Bureau of Alcohol, Tobacco,
Firearms and Explosives

Firearms Technology Industry Services Branch

DEC 22 2015

This refers to your correspondence to the Bureau of Alcohol, Tobacco, Firearms and Explosives (ATF), Firearms Technology Industry Services Branch (FTISB), which accompanied your submitted sample of an "Adjustable Pistol Stabilizing Brace" mounted on a semiautomatic pistol. Specifically, you asked whether the subject device could be lawfully installed on a handgun.

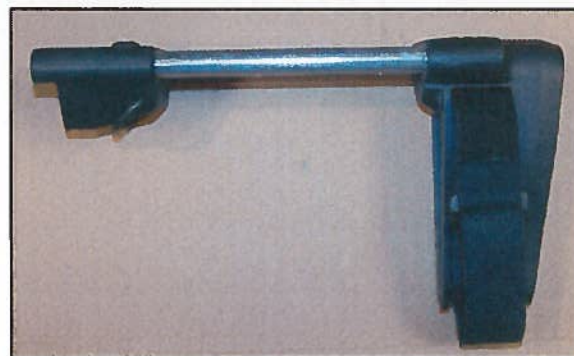
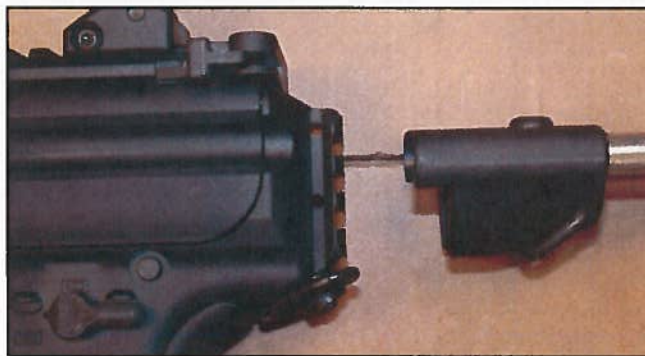
Further, the submitted brace contains a series of raised ridges at its rear (see photo below):

The subject ridges on the rear of the submitted sample serve no functional purpose in the design of a pistol brace; however, the ridges do provide a non-slip, gripping surface, a feature commonly associated with butt stocks/shoulder stocks as well as firearms designed and intended to be fired from the shoulder. You indicate production models will not have this raised surface so as to preclude its usefulness to be shouldered.

In closing, FTISB finds that the submitted sample is approved for use as a pistol stabilizing brace provided the raised ridges are removed from the rear of the device and not added at a later time.
